# Whirl Wind Propellers

## SERVICE LETTER

SL-GA-J2B-012714

**TO:** ALL OWNERS / OPERATORS OF AFFECTED PROPELLERS  
**SUBJECT:** BLADE CLAMP BOLT CRACK  
**DATE:** JANUARY 27, 2014

**FIGURE 1 (SL-GA-J2B-012714)**

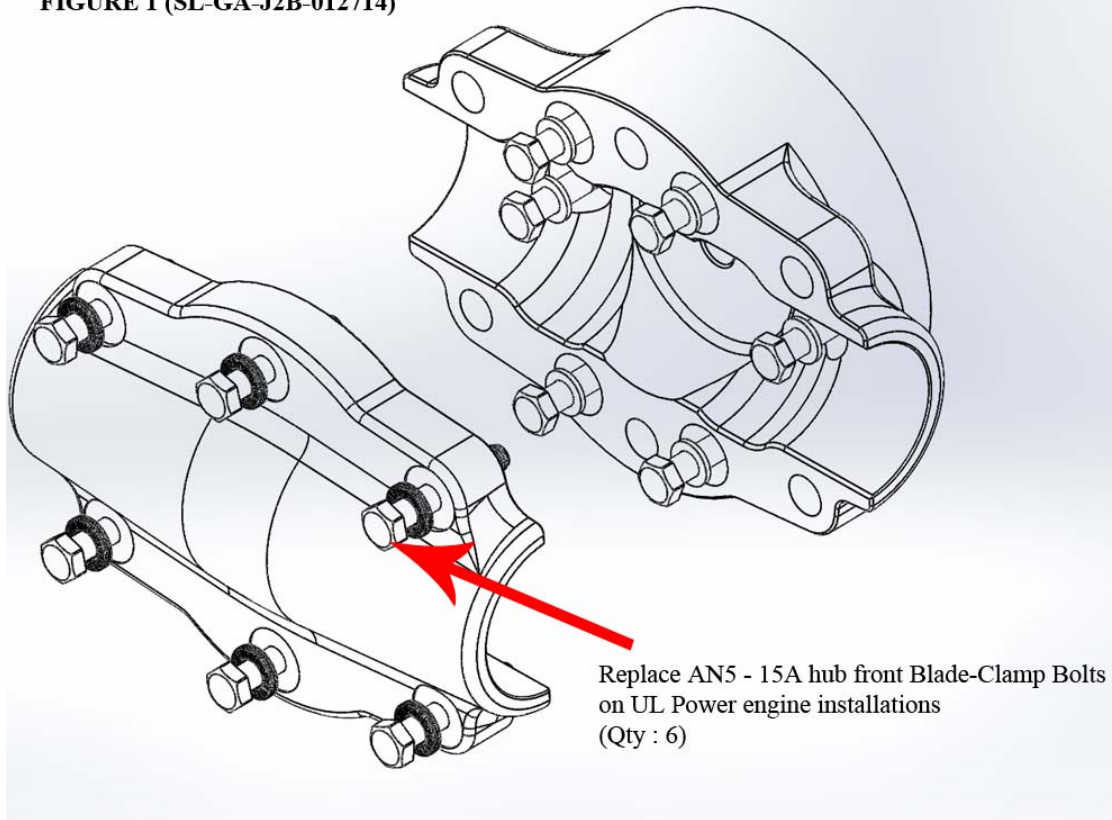
**ACTION:** *Reference Figure 1 on Page 2*

Affected propellers less than 1 year old:

Recommend replacement of all 6 front hub blade-clamp bolts (AN5-15A) at time of every Annual or every 100 hrs, whichever occurs first.

Affected propellers older than 1 year or with more than 100 hrs:

Mandatory replacement of all 6 front hub blade-clamp bolts (AN5-15A) before next flight.
